Aeronautical Study No.
2016-WTE-6204-OE
Prior Study No.
2014-WTE-5439-OE

**** MARKING & LIGHTING RECOMMENDATION ****

Structure:	Lighting Study for Wind Turbine Wind Turbine AWE 1
Location:	Antrim, NH
Latitude:	43-04-03.41N NAD 83
Longitude:	72-00-28.14W
Heights:	1431 feet site elevation (SE) 489 feet above ground level (AGL) 1920 feet above mean sea level (AMSL)

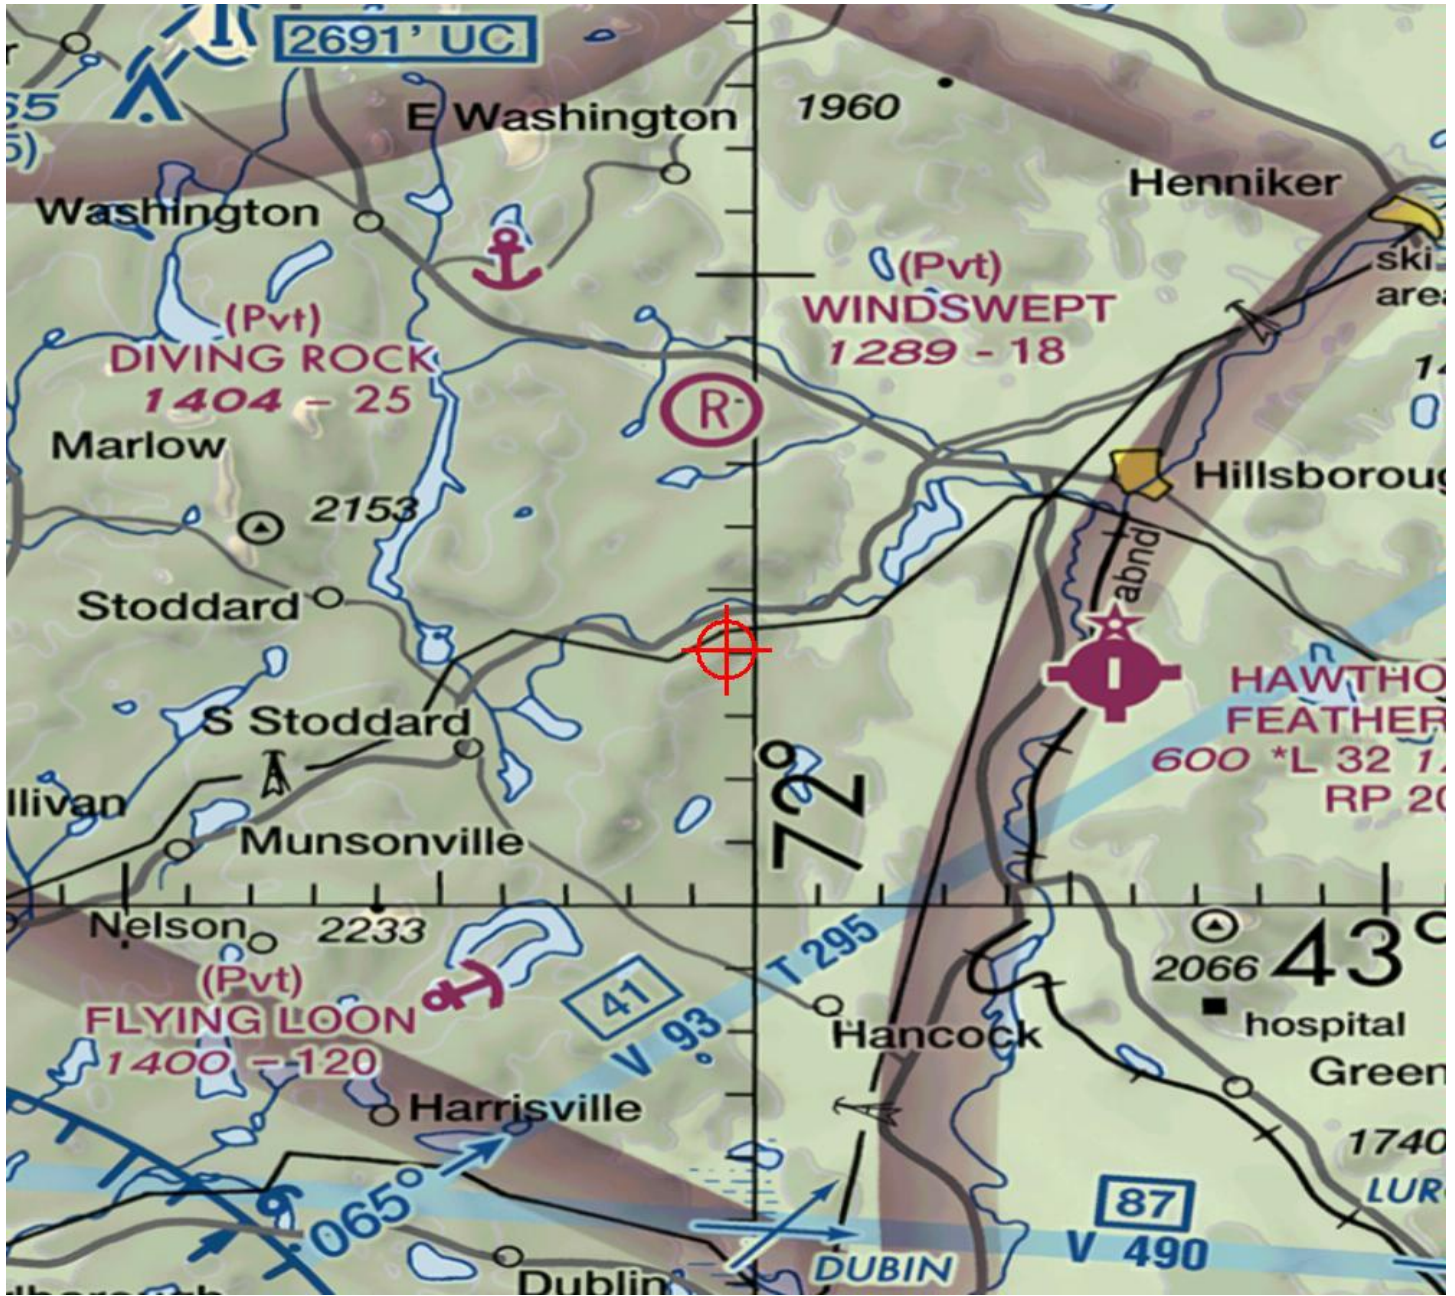
Based on this evaluation, we have no objection to the change provided the structure is marked/lighted in accordance with FAA Advisory Circular 70/7460-1, L Change 1 , Obstruction Marking and Lighting, white paint/synchronized red lights - Chapters 4,12&13(Turbines).

Your request for consideration to utilize an Aircraft Detection Lighting System to operate the recommended lighting is approved provided that the equipment meets established technical standards.

In order to ensure proper conspicuity of turbines at night during construction, all turbines should be lit with temporary lighting once they reach a height of 200 feet or greater until such time the permanent lighting configuration is turned on. As the height of the structure continues to increase, the temporary lighting should be relocated to the uppermost part of the structure. The temporary lighting may be turned off for periods when they would interfere with construction personnel. If practical, permanent obstruction lights should be installed and operated at each level as construction progresses. An FAA Type L-810 steady red light fixture shall be used to light the structure during the construction phase. If power is not available, turbines shall be lit with self-

contained, solar powered LED steady red light fixture that meets the photometric requirements of an FAA Type L-810 lighting system. The lights should be positioned to ensure that a pilot has an unobstructed view of at least one light at each level. The use of a NOTAM (D) to not light turbines within a project until the entire project has been completed is prohibited.

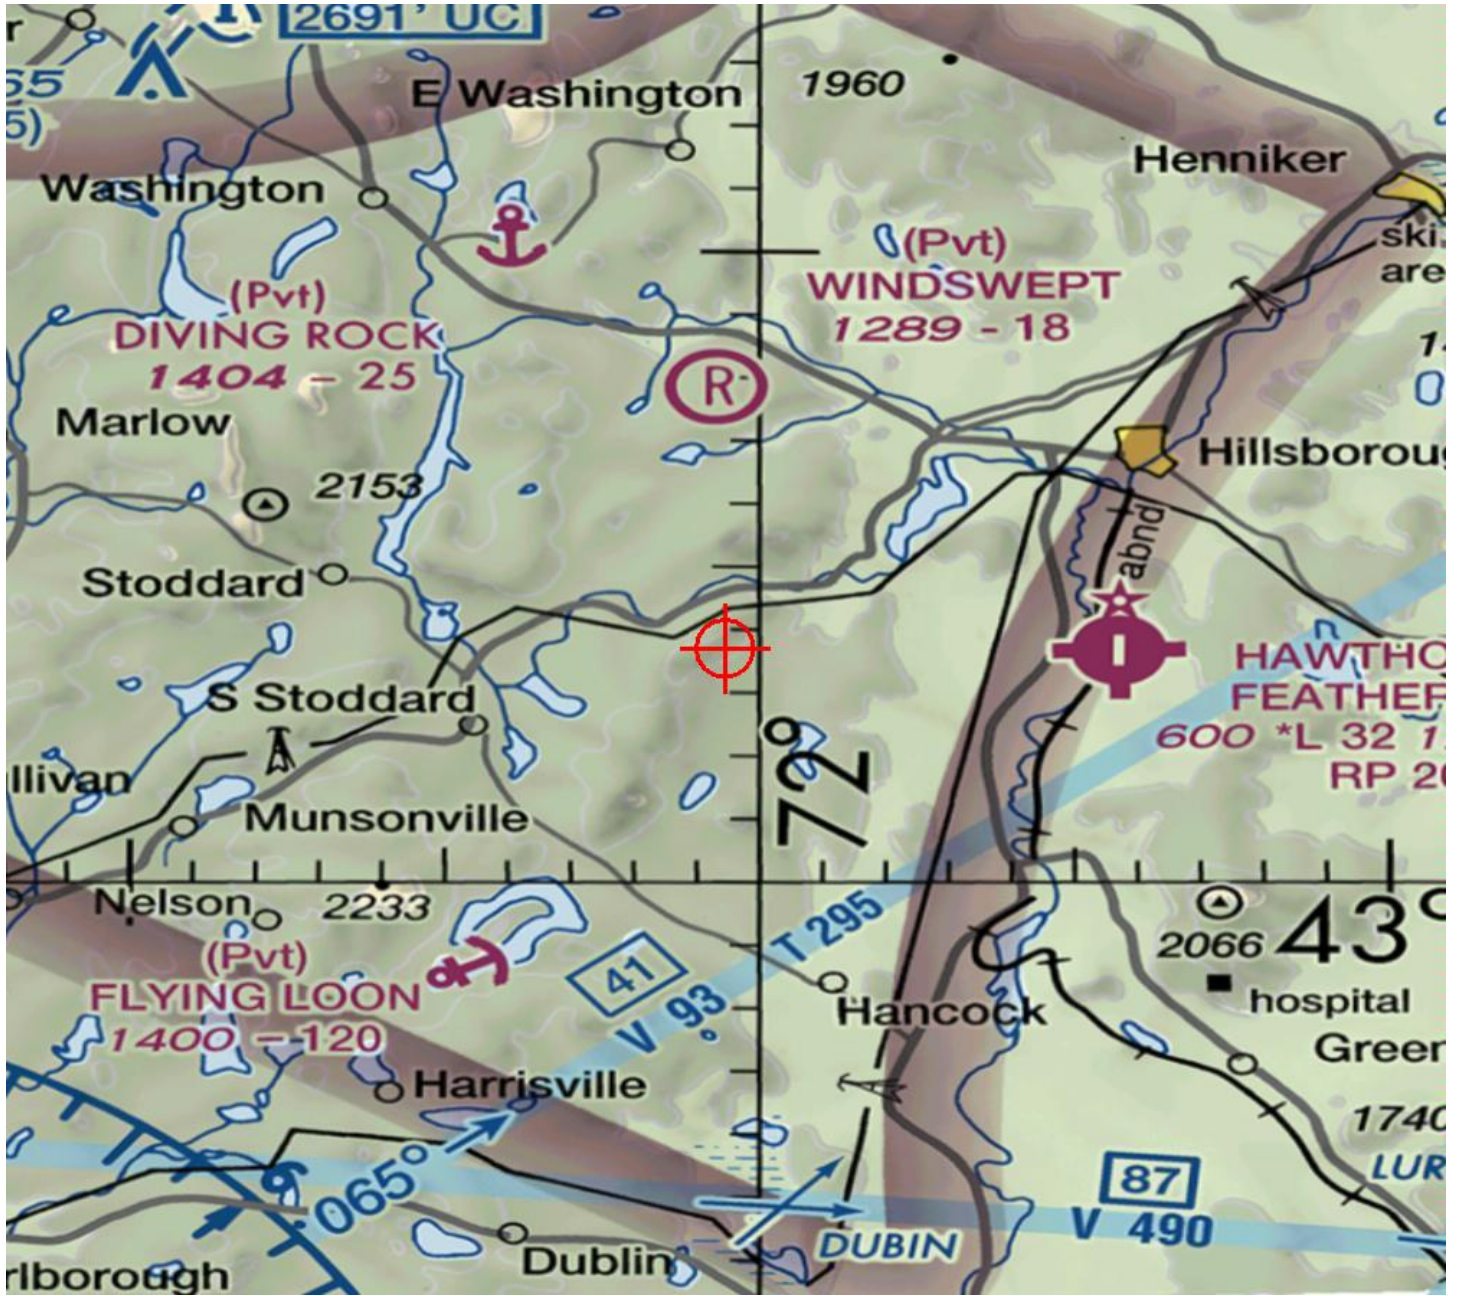
Based on this evaluation, we have no objection to the change provided the structure is marked/lighted in accordance with FAA Advisory Circular 70/7460-1, L Change 1 , Obstruction Marking and Lighting, white paint/synchronized red lights - Chapters 4,12&13(Turbines).

Your request for consideration to utilize an Aircraft Detection Lighting System to operate the recommended lighting is approved provided that the equipment meets established technical standards.

In order to ensure proper conspicuity of turbines at night during construction, all turbines should be lit with temporary lighting once they reach a height of 200 feet or greater until such time the permanent lighting configuration is turned on. As the height of the structure continues to increase, the temporary lighting should be relocated to the uppermost part of the structure. The temporary lighting may be turned off for periods when they would interfere with construction personnel. If practical, permanent obstruction lights should be installed and operated at each level as construction progresses. An FAA Type L-810 steady red light fixture shall be used to light the structure during the construction phase. If power is not available, turbines shall be lit with self-

contained, solar powered LED steady red light fixture that meets the photometric requirements of an FAA Type L-810 lighting system. The lights should be positioned to ensure that a pilot has an unobstructed view of at least one light at each level. The use of a NOTAM (D) to not light turbines within a project until the entire project has been completed is prohibited.

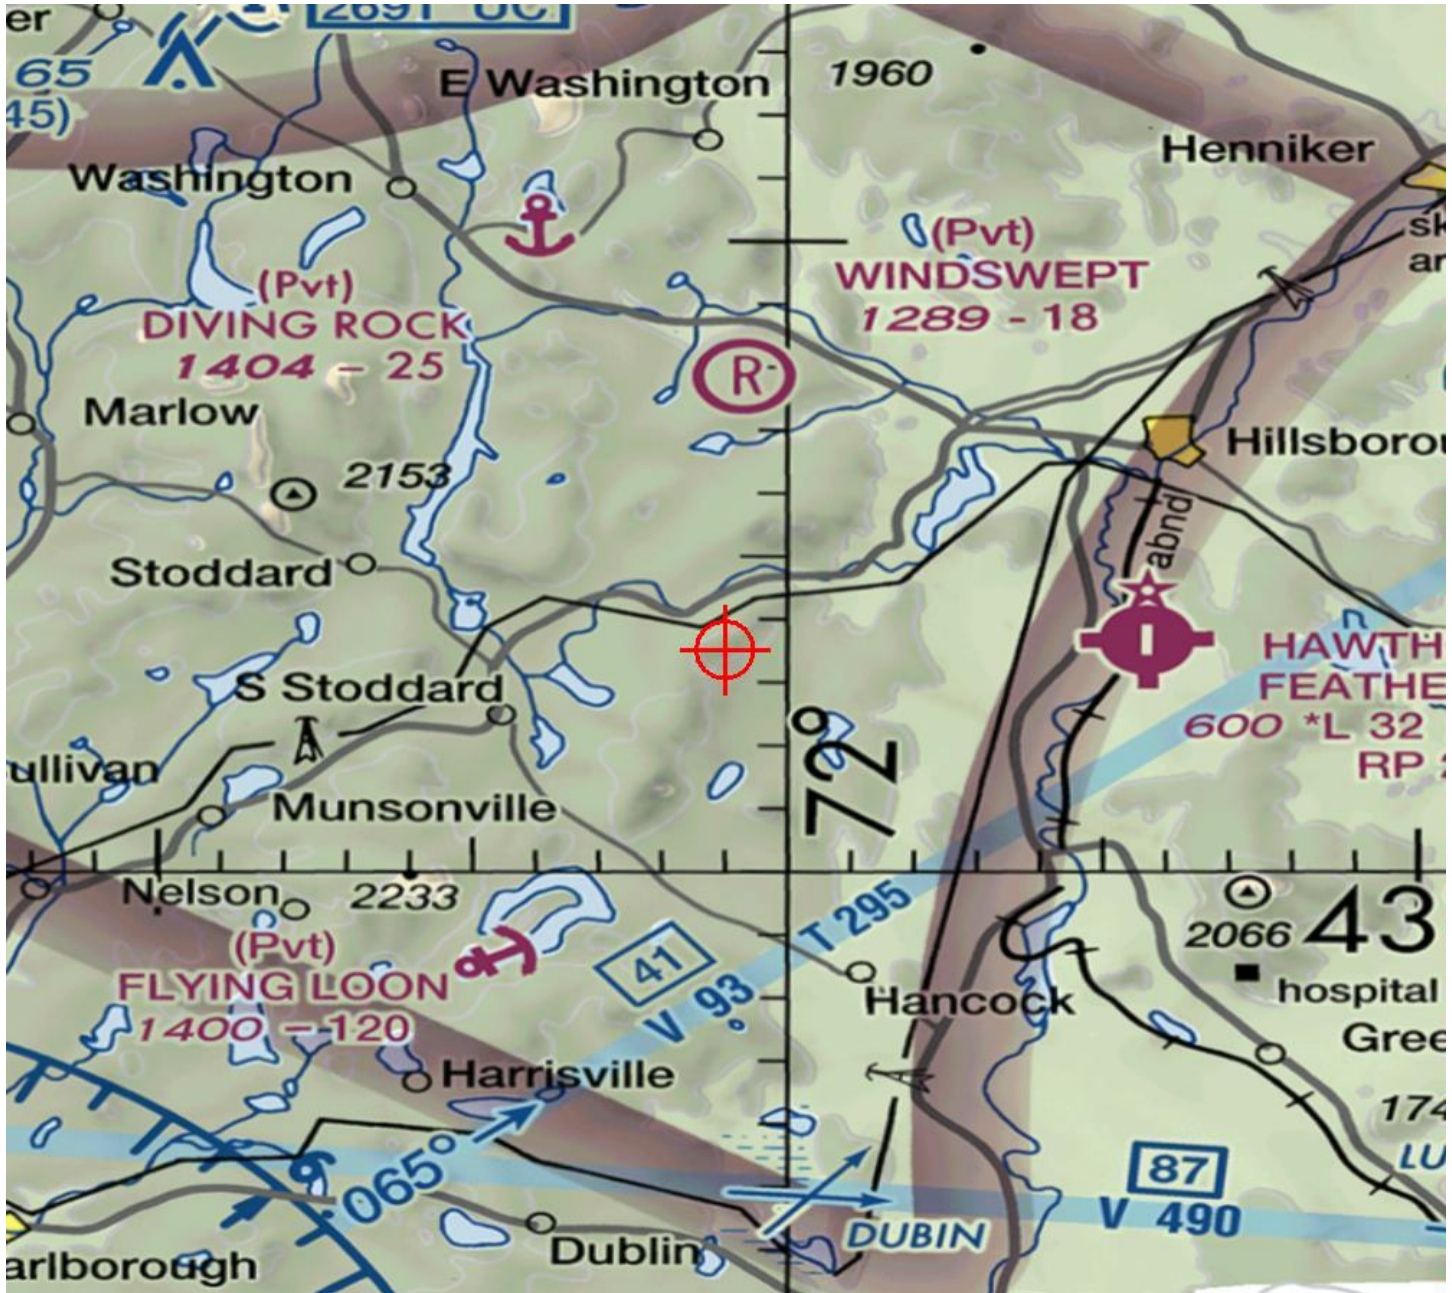
Based on this evaluation, we have no objection to the change provided the structure is marked/lighted in accordance with FAA Advisory Circular 70/7460-1, L Change 1 , Obstruction Marking and Lighting, white paint/synchronized red lights - Chapters 4,12&13(Turbines).

Your request for consideration to utilize an Aircraft Detection Lighting System to operate the recommended lighting is approved provided that the equipment meets established technical standards.

In order to ensure proper conspicuity of turbines at night during construction, all turbines should be lit with temporary lighting once they reach a height of 200 feet or greater until such time the permanent lighting configuration is turned on. As the height of the structure continues to increase, the temporary lighting should be relocated to the uppermost part of the structure. The temporary lighting may be turned off for periods when they would interfere with construction personnel. If practical, permanent obstruction lights should be installed and operated at each level as construction progresses. An FAA Type L-810 steady red light fixture shall be used to light the structure during the construction phase. If power is not available, turbines shall be lit with self-

contained, solar powered LED steady red light fixture that meets the photometric requirements of an FAA Type L-810 lighting system. The lights should be positioned to ensure that a pilot has an unobstructed view of at least one light at each level. The use of a NOTAM (D) to not light turbines within a project until the entire project has been completed is prohibited.

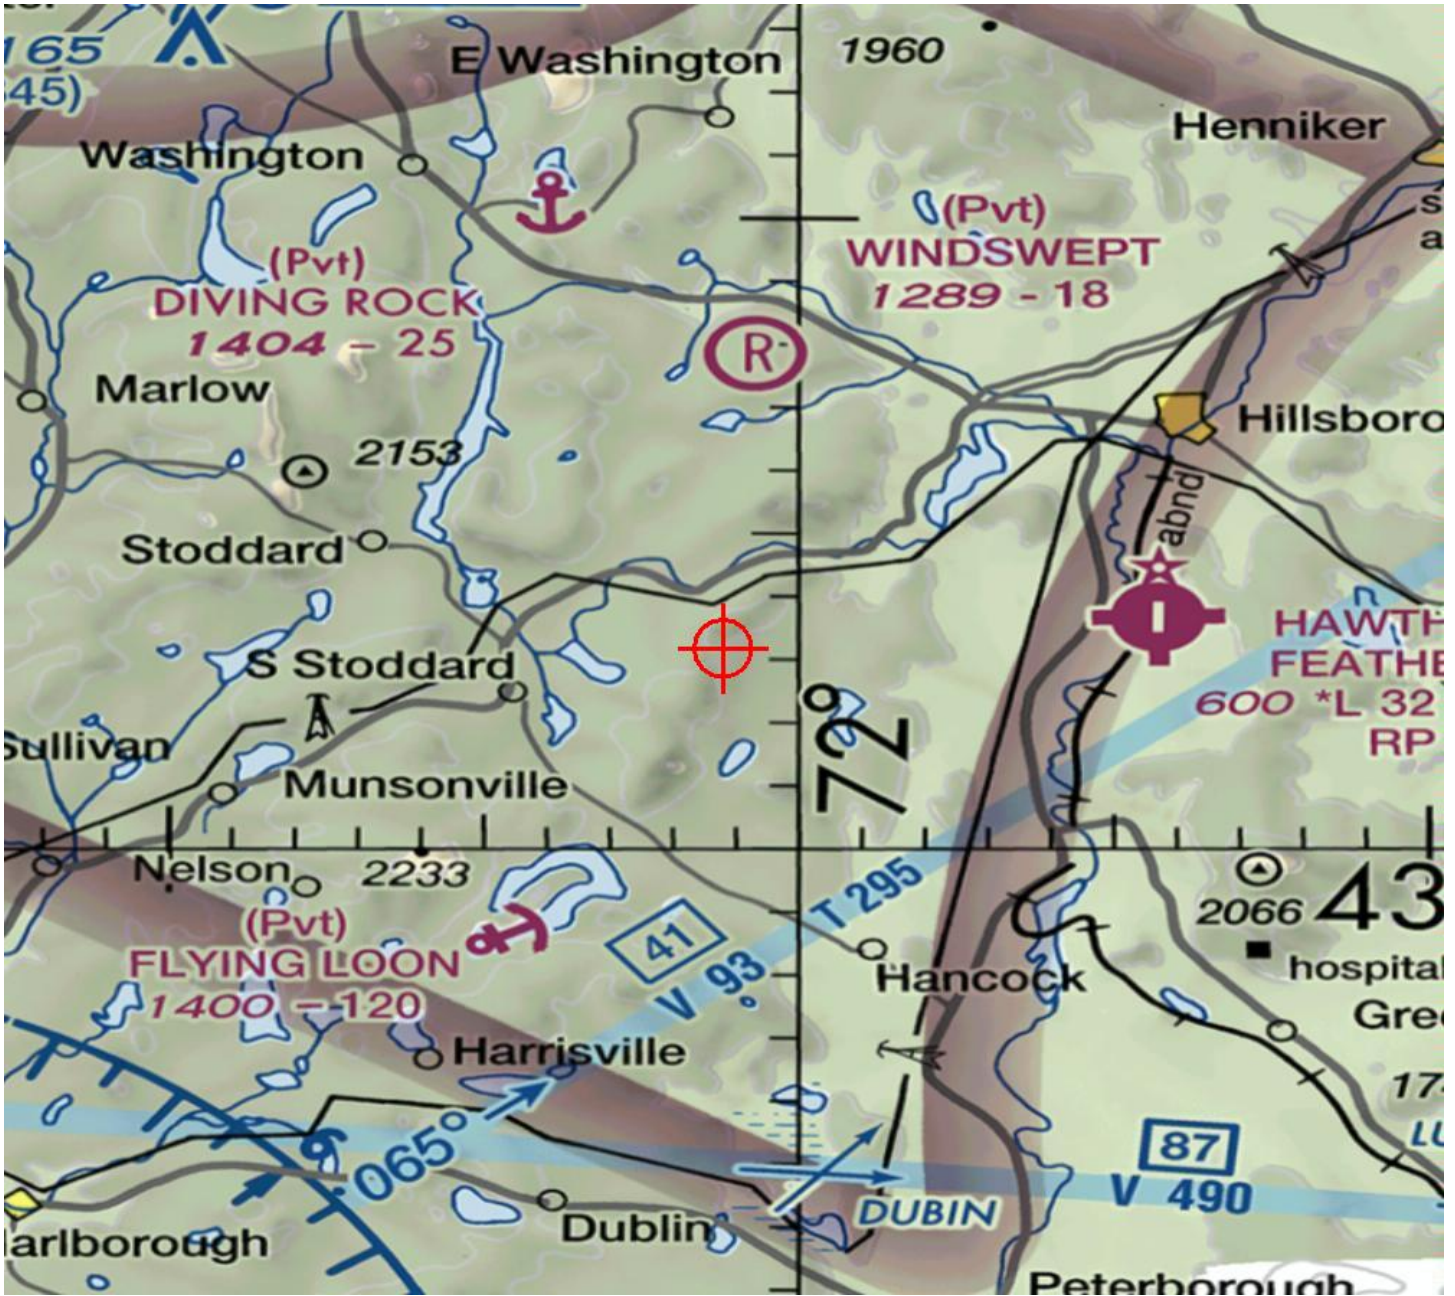
Based on this evaluation, we have no objection to the change provided the structure is marked/lighted in accordance with FAA Advisory Circular 70/7460-1, L Change 1 , Obstruction Marking and Lighting, white paint/synchronized red lights - Chapters 4,12&13(Turbines).

Your request for consideration to utilize an Aircraft Detection Lighting System to operate the recommended lighting is approved provided that the equipment meets established technical standards.

In order to ensure proper conspicuity of turbines at night during construction, all turbines should be lit with temporary lighting once they reach a height of 200 feet or greater until such time the permanent lighting configuration is turned on. As the height of the structure continues to increase, the temporary lighting should be relocated to the uppermost part of the structure. The temporary lighting may be turned off for periods when they would interfere with construction personnel. If practical, permanent obstruction lights should be installed and operated at each level as construction progresses. An FAA Type L-810 steady red light fixture shall be used to light the structure during the construction phase. If power is not available, turbines shall be lit with self-

contained, solar powered LED steady red light fixture that meets the photometric requirements of an FAA Type L-810 lighting system. The lights should be positioned to ensure that a pilot has an unobstructed view of at least one light at each level. The use of a NOTAM (D) to not light turbines within a project until the entire project has been completed is prohibited.
